Intel® Desktop Board 845GL Chipset Family Specification Update

Release Date: November 2003

Order Number: A98269-009

Figure 1. Desktop Board D845GLAD Components

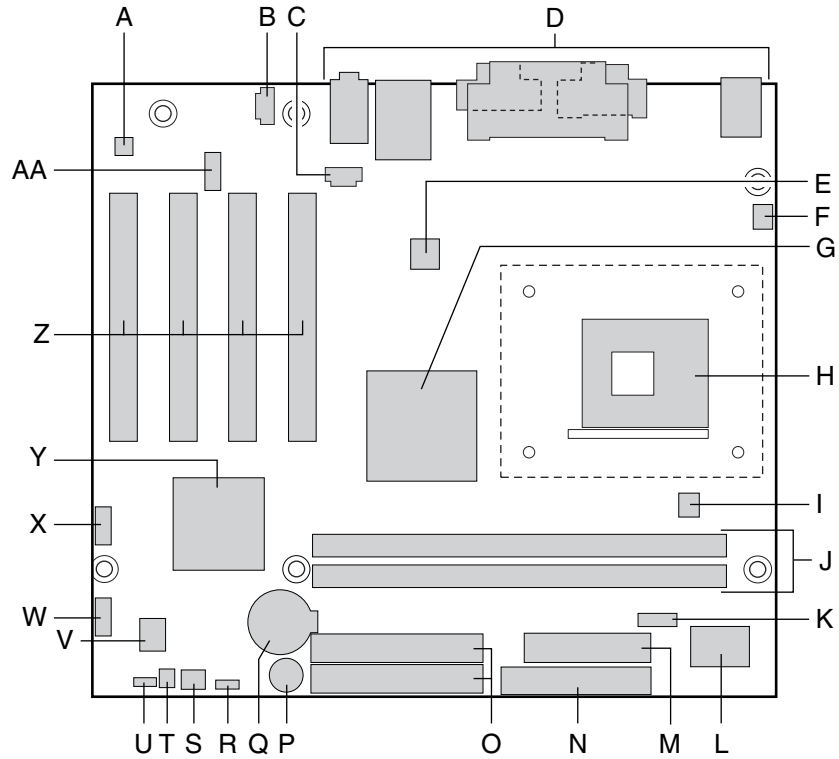
4. Change to Description of Section 1.4, Board Layout

Section 1.4, Board Layout will change in its entirety as follows:

Figure 1 shows the location of the major components on the Desktop Board D845GLAD.

A	Audio codec	O	IDE connectors
B	Auxiliary line-in connector	P	Speaker
C	ATAPI CD-ROM connector	Q	Battery
D	Back panel connectors	R	Auxiliary front panel power LED connector
E	+12V power connector (ATX12V)	S	Front chassis fan connector
F	Rear chassis fan connector	T	Chassis intrusion connector
G	Intel® 82845GV Graphics and Memory Controller Hub (GMCH)	U	BIOS Setup configuration jumper block
H	mPGA478 processor socket	V	4 Mbit Firmware Hub (FWH)
I	Processor fan connector	W	Front panel connector
J	DIMM sockets	X	Front panel USB connector
K	Serial port B connector	Y	Intel® 82801DB I/O Controller Hub (ICH4)
L	I/O Controller	Z	PCI bus add-in card connectors
M	Power connector	AA	Front panel audio connector
N	Diskette drive connector

Figure 3. Audio, Power, and Hardware Control Connectors

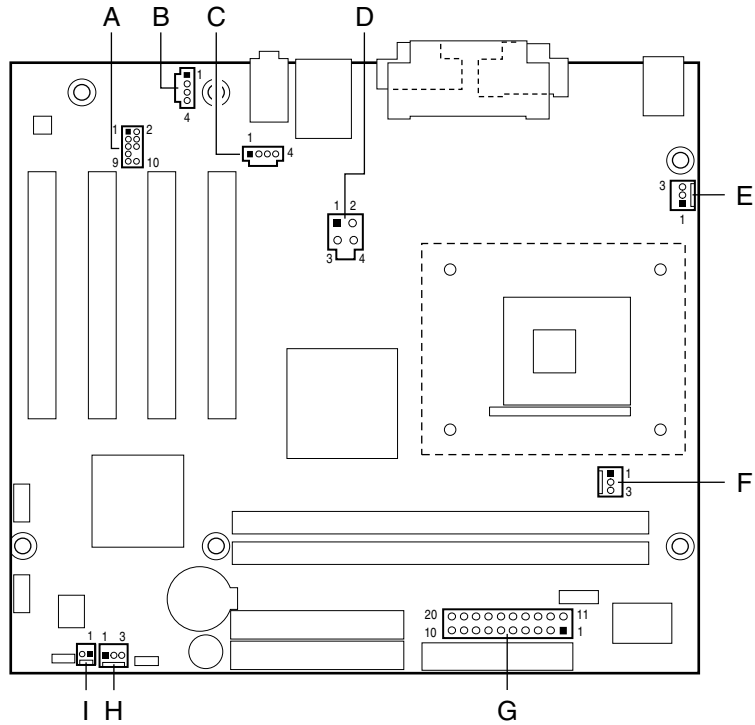
6. Change to Description of Section 2.2.2.2, Audio, Power, and Hardware Control Connectors

Section 2.2.2.2, Audio, Power, and Hardware Control Connectors will change in its entirety as follows:

Figure 3 shows the location of the audio, power, and hardware control connectors.

Item	Description	For more information see:
A	Front panel audio	Table 3
B	Auxiliary line in, ATAPI style (white)	Table 4
C	ATAPI CD-ROM (black)	Table 5
D	+12 V power connector (ATX12V)	Table 6
E	Rear chassis fan	Table 7
F	Processor fan	Table 8
G	Main power	Table 9
H	Front chassis fan	Table 10
I	Chassis intrusion	Table 11

Figure 6. Location of the Jumper Blocks

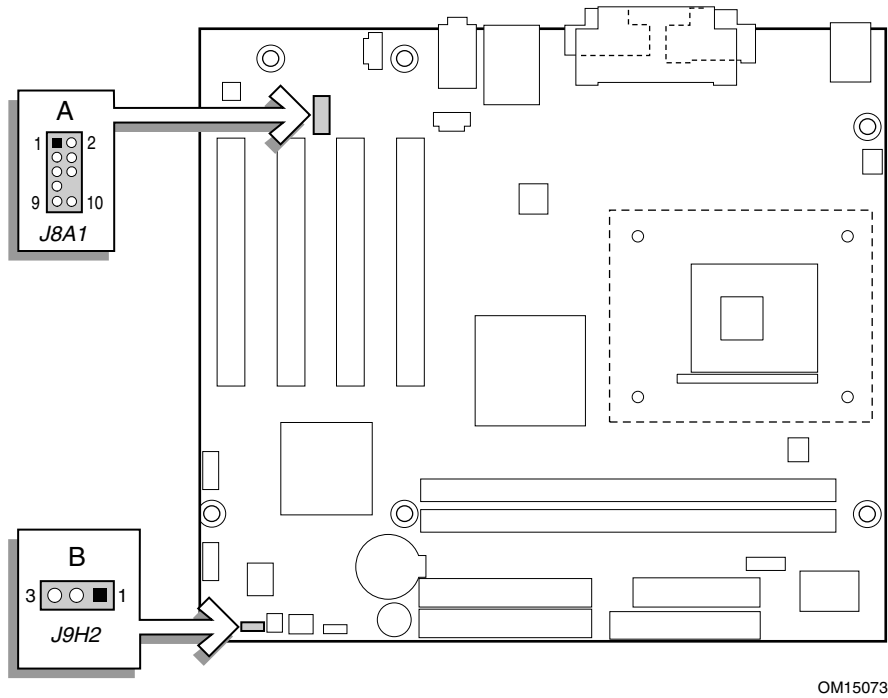
8. Change to Description of Section 2.3, Jumper Block

Section 2.3, Jumper Block will change in its entirety as follows:

Figure 6 shows the location of the jumper blocks.

Item	Description	Reference Designator
A	Front panel audio connector/jumper block	J8A1
B	BIOS Setup configuration jumper block	J9H2

2.3.1 FRONT PANEL AUDIO CONNECTOR/JUMPER BLOCK

This connector has two functions:

- With jumpers installed, the audio line out signals are routed to the back panel audio line out connector.
- With jumpers removed, the connector provides audio line out and mic in signals for front panel audio connectors.
